# CITY OF ALBUQUERQUE

**RE: Paseo del Norte Sports Complex, Tract A, Loop Industrial Park  
Grading and Drainage Plan  
Engineer's Stamp Date 3-12-2015 (File: C17-D008)**

Based upon the information provided in your submittal received 3-09-15, the above referenced plan can be approved for a grading permit based on the rough grades shown on the plan, but it cannot be approved for Building Permit. Final grades still need to be submitted, reviewed, and approved, and the following comments need to be addressed prior to obtaining a building permit:

## grading and drainage plan

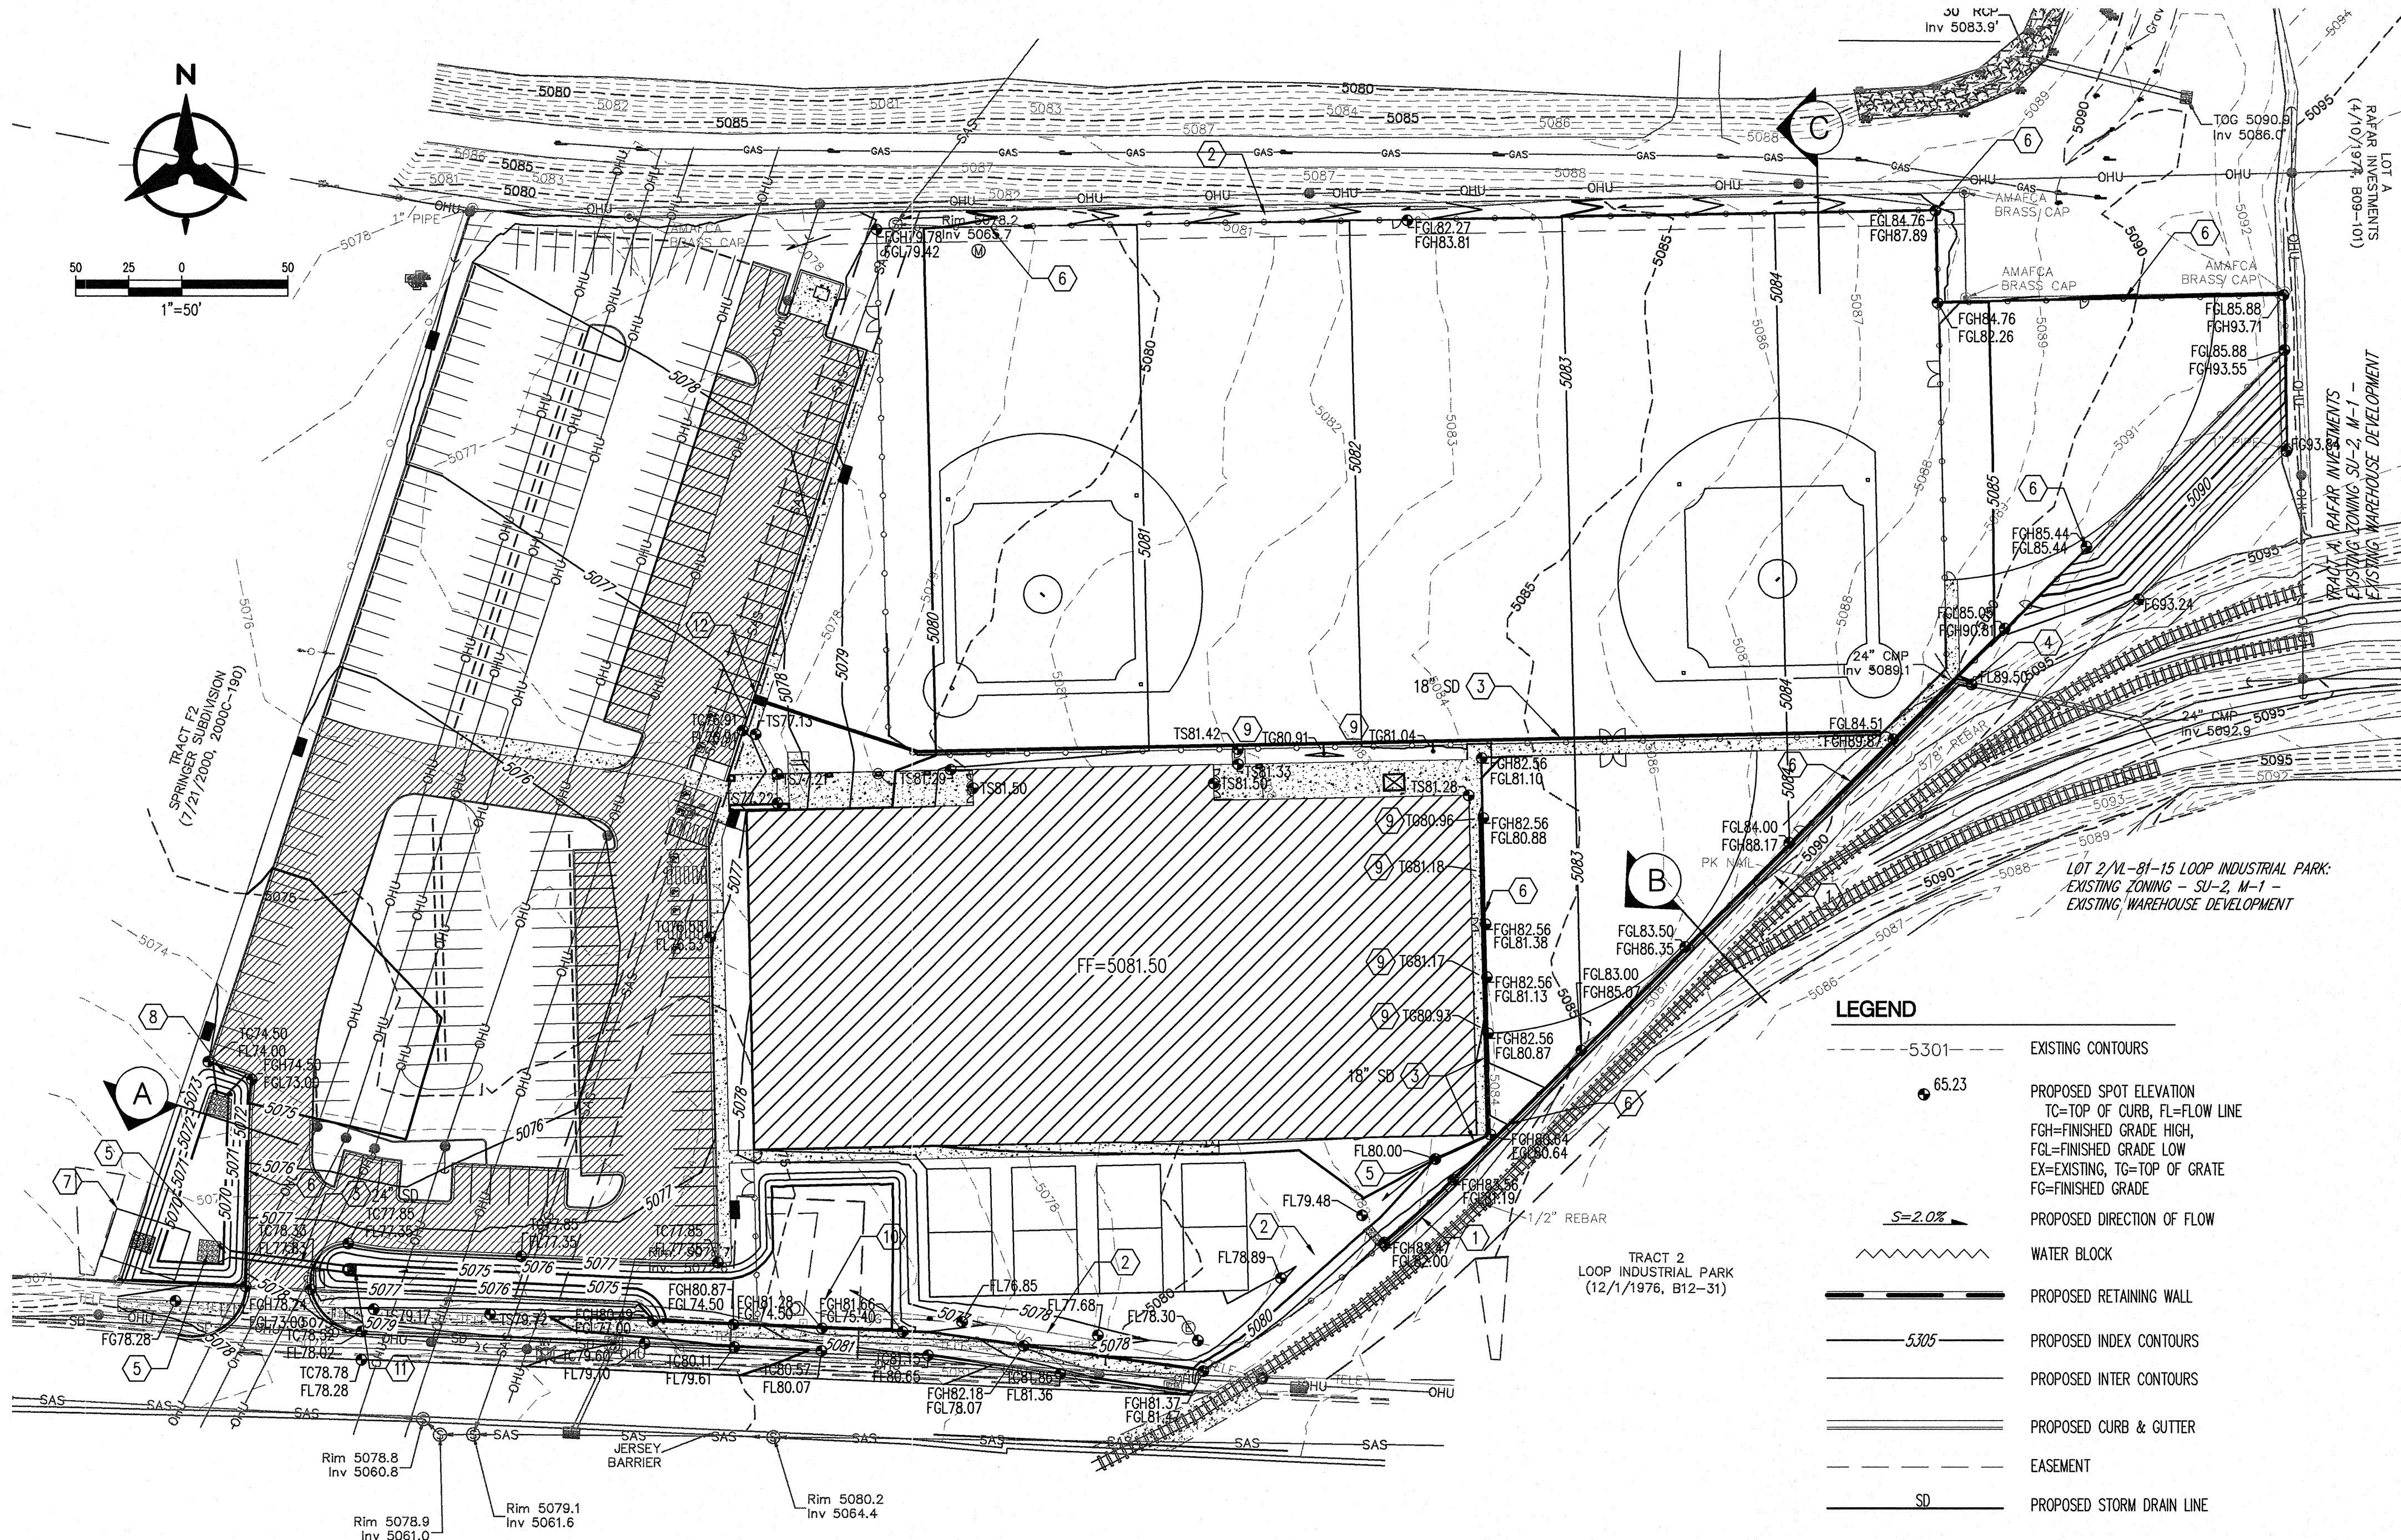
- 1) Provide a survey benchmark, and clearly show the property line and easements.
- 2) The comment letter from November 10, 2014 asks to show both an emergency overflow for Pond A and 1 foot of freeboard. These comments still have to be addressed.

- 3) Proposed elevations along the deceleration lane and along the railroad tracks need to be more legible. The waterblock needs to be more clearly defined at the access off of Paseo del Norte.

- 4) Keyed Note 2 appears to be calling out riprap blankets in the wrong location.
- 5) For all on-site proposed storm drains on the Grading and Drainage Plan, show the pipe flow that is being conveyed, the pipe size and slope, and the capacity calculations. Also, provide capacity calculations for all on-site sidewalk culverts, inlets, and weir.

- 6) Provide all invert elevations for beginning and end of all proposed storm drains. Call out pipe bends and manholes where the storm drain pipes change direction and provide invert elevations at these locations.

- 7) Show slope and capacity calculations for concrete ribbon channel. Provide detail of how the 24" CMP connects into the ribbon channel. Detail downstream end of ribbon channel along with the riprap shown on the plan.
- 8) Provide key spot elevations for construction of the parking lot. Also provide more spot elevations along the building on south and west side.
- 9) Provide full AHYMO input and output files in addition to the summary provided. Show the first flush calculations on the drainage management plan.
- 10) Provide off-site basin map that is discharging to the on-site. Address off-site flow that is discharging to the site from the east just north of the railroad tracks.
- 11) Provide a way to capture flow along the east side of the building and then discharge it to either the new storm to the north or to the south side of the building.
